APPLICATION NO.	FILING DATE	FIRST NAMED INVENTOR	ATTORNEY DOCKET NO.	CONFIRMATION NO.
10/533,550	11/17/2005	Andrew Graham	1432.116.101/P29858	6310
45782 7590 11/01/2007 DICKE, BILLIG & CZAJA, PLLC FIFTH STREET TOWERS 100 SOUTH FIFTH STREET MINNEAPOLIS, MN 55402			EXAMINER LOPEZ ESQUERRA, ANDRES	
			ART UNIT 2818	PAPER NUMBER
			MAIL DATE 11/01/2007	DELIVERY MODE PAPER

Office Action Summary

DETAILED ACTION

Figure 2

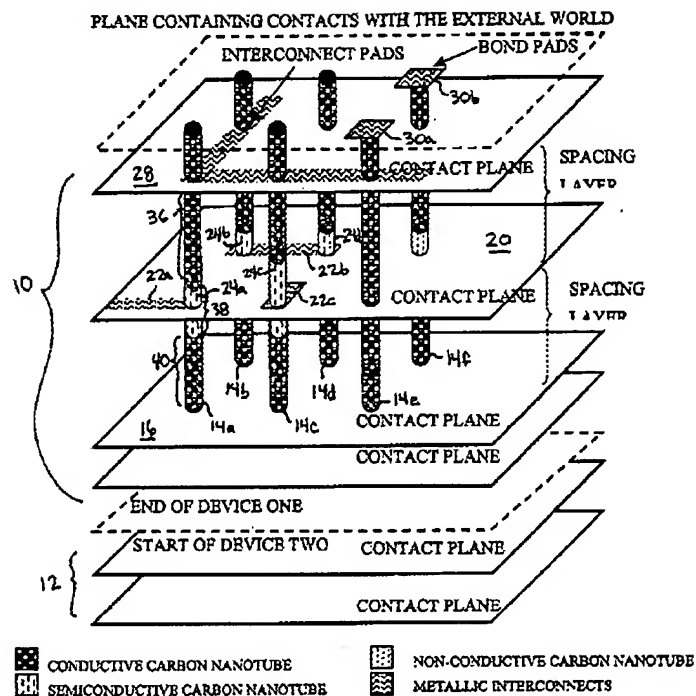
8. As for claims 22 and 41 – 43, Mancevski discloses (Page 3 [0040]) and shows in Fig. 2 a carbon nanotube transistor and method of manufacturing the same comprising:
- a first electrically conductive layer (16);
 - a middle layer /spacing layers(10), formed partially from dielectric material, on the first electrically conductive layer;
 - a second electrically conductive layer on the middle layer (28), and;
 - a nanostructure (14) integrated in a via hole/vertically aligned holes introduced into the middle layer, the nanostructure further comprising a first end portion that is coupled to the first electrically conductive layer and a second end portion that is coupled to the second electrically conductive layer (as shown in the Fig, 2 both ends of the nanotubes are imbedded in the contact layer);

- e. wherein the middle layer, between two adjacent dielectric sublayers/spacing layers, has a third electrically conductive layer (20), the thickness of which is less than the thickness of at least one of the dielectric sublayers (as shown in Fig 2, the contact plane is thinner than the spacing layers).
9. Mancevski fails to disclose use of a ring structure formed from an electrically insulating material as gate-insulating region of the field-effect transistor is arranged in the third electrically conductive layer, which forms the gate electrode of the field-effect transistor, along the via hole that has been introduced therein.

16. As for claims 24 – 25, Mancevski shows in Fig. 2 that the third conductive layer/contact layer (20) surrounds the nanostructure in the middle of the transistor as well as it been thinner than both dielectric layer/spacing layers.

18. As for claim 28, Mancevski shows in Fig. 2 that creation of a second transistor (12) next to the original transistor (10).

FIG. 1

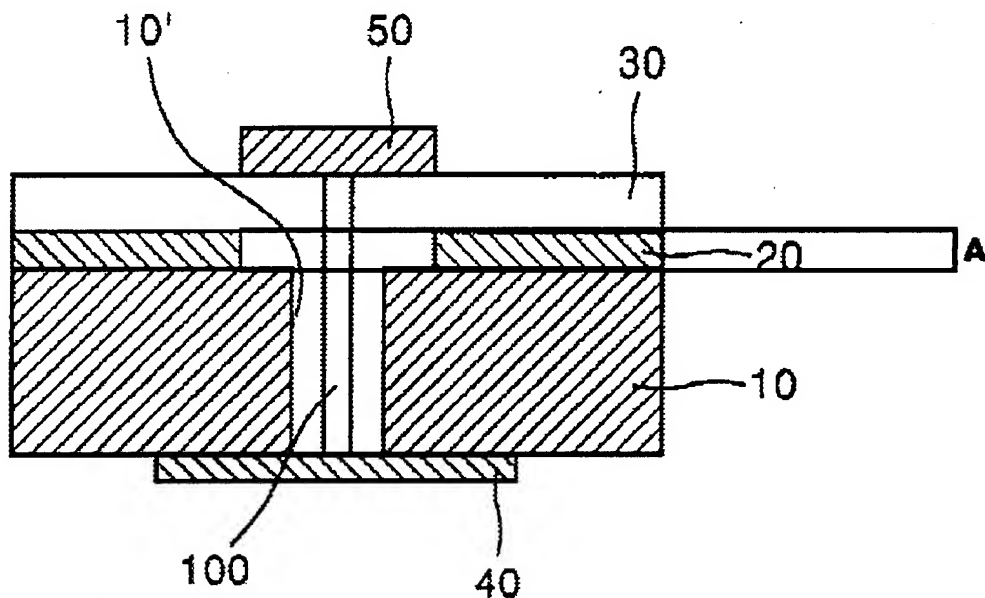
10. Choi discloses (Page 2, [0028]) and shows in Fig. 1 a FET transistor and method of manufacturing the same comprising a nanostructure (100) and the use of an insulation ring (A) in the area of the gate (20) of the transistor.

11. Choi is evidence that ordinary workers in the art would find a reason, suggestion or motivation to use a ring structure in the gate area made of an insulating material.

12. Therefore, it would have been obvious to one of ordinary skill in the art at the time of the invention was made to modify Mancevski by using a ring structure in the gate area made of an insulating material for advantages such as achieving a high-density integration in the final structure of the FET (Page 2, [0028]).

Fig. 1

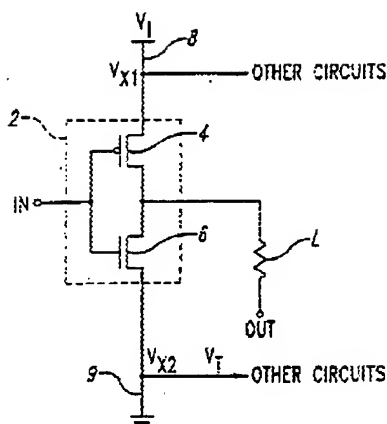
25. Claim 29 rejected under 35 U.S.C. 103(a) as being unpatentable over Mancevski in view of Martin et al. US 2001/0019279 (Martin).
